Delegated Decision Report

Application No:	25/0177	Statutory Period Expires:	06 February 2026
------------------------	----------------	----------------------------------	-------------------------

Site:	<i>Llanwern Works Queensway Llanwern Newport South Wales</i>		
Proposal:	<i>RESERVED MATTERS APPLICATION RELATING TO LAYOUT, SCALE, APPEARANCE, ACCESS AND LANDSCAPING FOR 3 NO. COMMERCIAL UNITS (USE CLASS B1, B2, B8) PURSUANT TO OUTLINE PLANNING PERMISSION 06/0471 FOR A MIXED USE REGENERATION OF THE FORMER LLANWERN STEELWORKS AND PARTIAL DISCHARGE OF CONDITIONS 01 (RESERVED MATTERS), 08 (MATERIALS), 09 (DETAILS OF HARD LANDSCAPED ACCESS), 10 (BOUNDARY TREATMENTS), 11 (MANAGEMENT STRATEGY FOR MAINTENANCE OF OPEN SPACE), 12 (OFF STREET PARKING AND CYCLE PARKING), 15 (EMERGENCY ACCESS), 16 (DETAILS OF ROADS/CYCLEWAYS/FOOTWAYS), 18 (ESTATE ROADS), 22 (STREET LIGHTING AND CAR PARKING AREAS), 24 (SITE LEVELS), 33 (SURFACE WATER DISPOSAL), 34 (FOUL AND SURFACE WATER DRAINAGE), 39 (SUSTAINABILITY STATEMENT) AND 43 (FIRE FIGHTING ACCESS)</i>		
Applicant:	<i>Indurent Logistics Propco A8 Ltd</i>

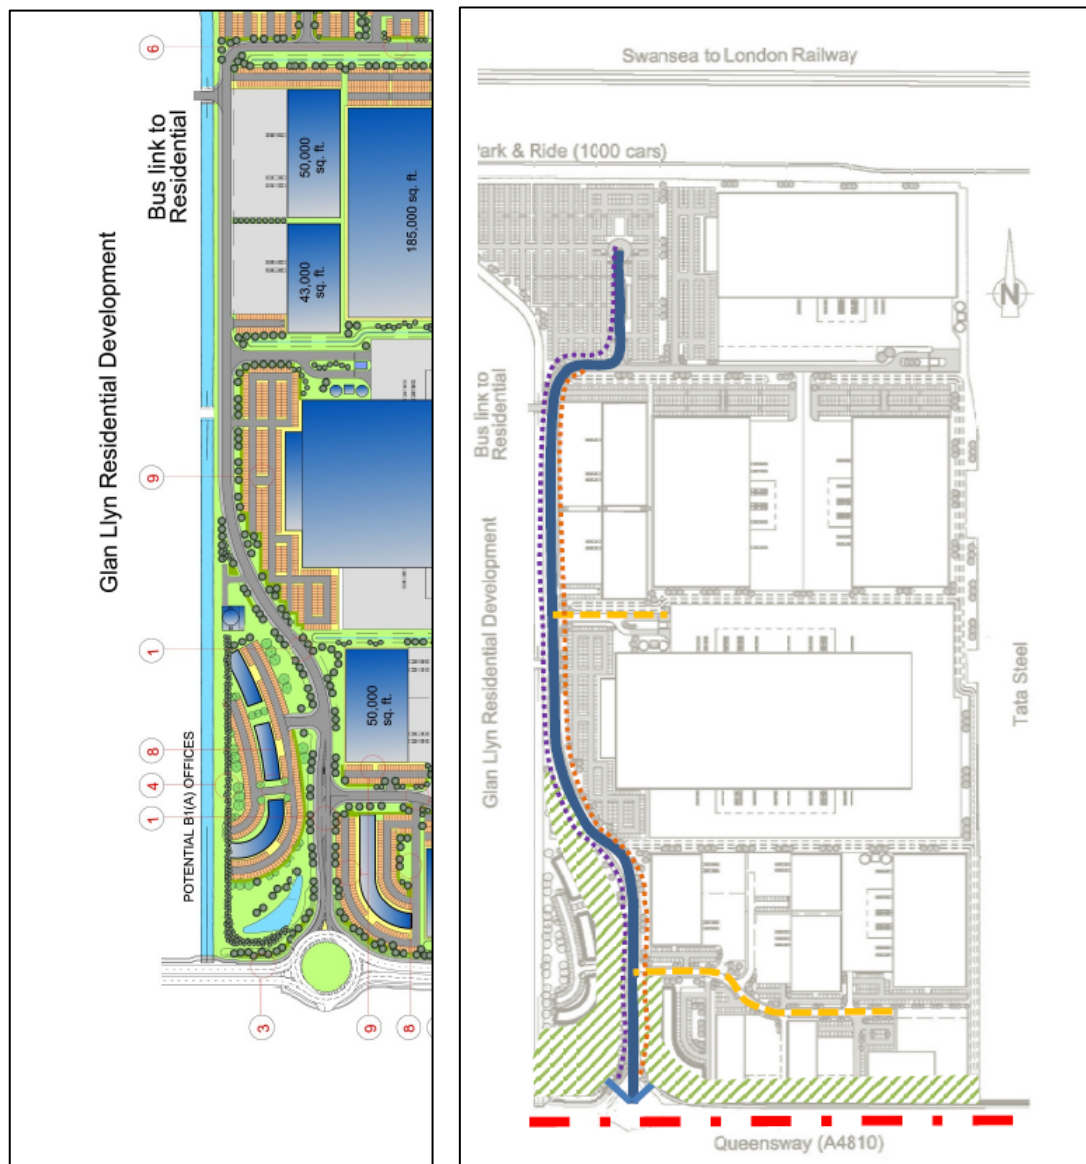
- 8.1 Key Issues are:
 - Design & Appearance
 - Compliance with the approved sub-area masterplan
 - Access & Servicing
 - Impact on adjacent residential phases
 - Outlook
 - Noise
 - Mitigation
 - Planting
 - Conditions

- 8.2 The proposed buildings are of similar materials, scale and appearance to those already constructed on Indurent Park and are acceptable in terms of appearance given the proposed design and materials.
- 8.3 In terms of scale they are large in terms of footprint and height and are clearly intended to be used in similar uses to those units already built on the park. In principle those uses are acceptable having been agreed at Outline stage. However under this submission the impacts of scale and siting on adjacent land uses are highly relevant.
